BACKGROUND

CITY OF OAKLAND PLANNING COMMISSION

Case File: PLN17428 / PUDF07
Applicant: Panoramic Interest, Zac Shore
Address: 500 Kirkham Street
Zone: S-15W
Height Area: 160 ft

PROJECT REVISIONS

1 SITE PLAN
1" = 30'-0"

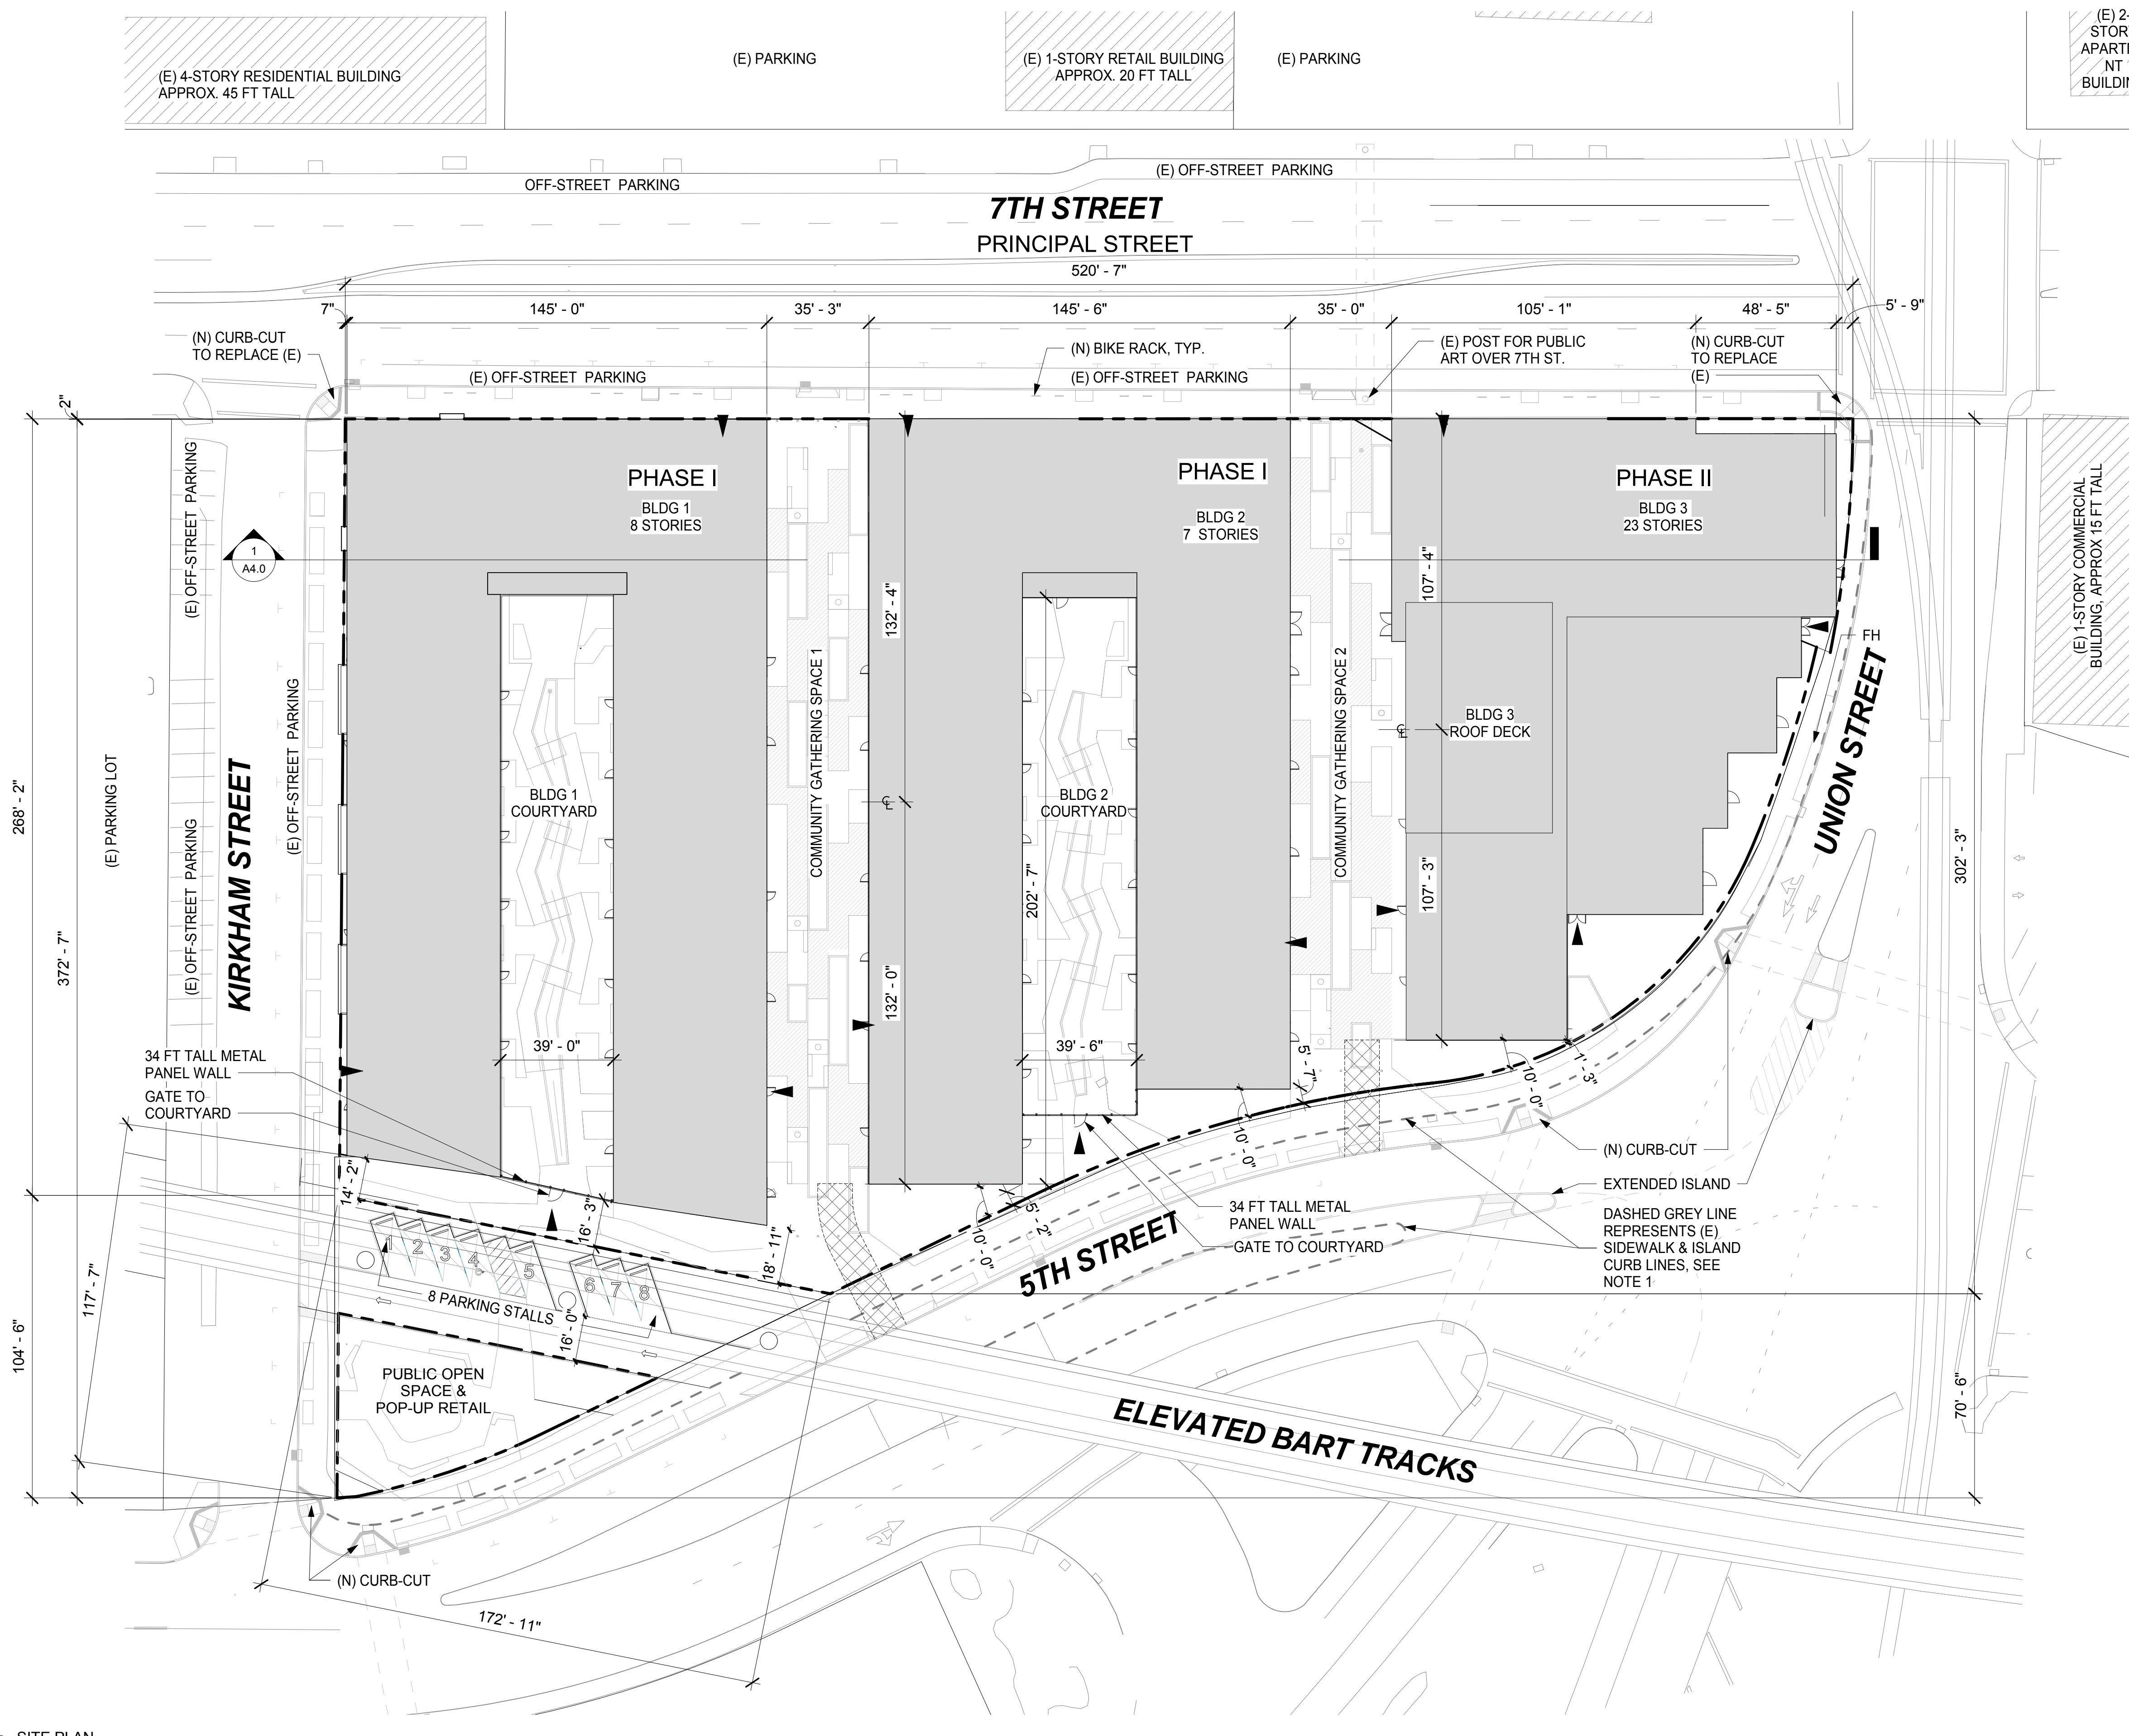
Staff Comments (based on original plans)	Applicant Responses	Staff Comments
<p>Site Planning 1/Pedestrian Circulation: ... the edges of the buildings and the areas where the on-site open space meet the public rights-of-way are not detailed enough to indicate articulated, welcoming project entries with appropriate gateway and amenity features.</p>	<p>Ground floor spaces are a mix of retail and flex spaces to activate the ground plane. Lobbies are centrally located to provide glazed through views into the courtyards of the two mid-rise buildings, Pedestrian streets are bracketed by retail and flex spaces to anchor the site and</p>	<p>Sheets A5.2 and A5.3 of the revised plans show the entries of the community gathering pathways along 7th St. The ground floor of the building corners has tall ceilings and glazing for transparency. To improve the entries to the open space it is suggested that more creative amenity features</p>

program. Ground plane storefronts range between 18'-24'.	are provided to create more emphasis at the open space entries.
Staff Comments (based on original plans)	Applicants Responses	Staff Comments
<p><u>Site Planning 2/ Vehicular Circulation:</u> ...the eight-space surface parking lot is prominent in that it is unenclosed and near the property line with the public right-of-way and will require a Conditional Use Permit for an open Nonresidential facility.</p>	<p>The 8 surface parking spaces as noted are located under the BART tracks. They are further screened from the street by the BART columns that support the tracks and occur at the edges of the public right of way.</p>	<p>The revised plans show the same parking count and parking lot configuration, and thus it will require the applicant to apply for a Conditional Use Permit for an open nonresidential facility.</p>
<p><u>Site Planning 3/ Service Circulation:</u> ...it is unclear how some of the flex spaces on Buildings 1 and 2 will have convenient access to the service rooms. The plans do not show any internal access to the service rooms and would require tenants of the flex spaces to walk at least 280 feet to the closes service rooms.</p>	<p>The retail/flex spaces would incorporate service space based on use and would be part of future TI.</p>	<p>The revised plans do not show changes as recommended. Staff believes that at this review level, the project plans need to clarify how service circulation will work on this large development project.</p>
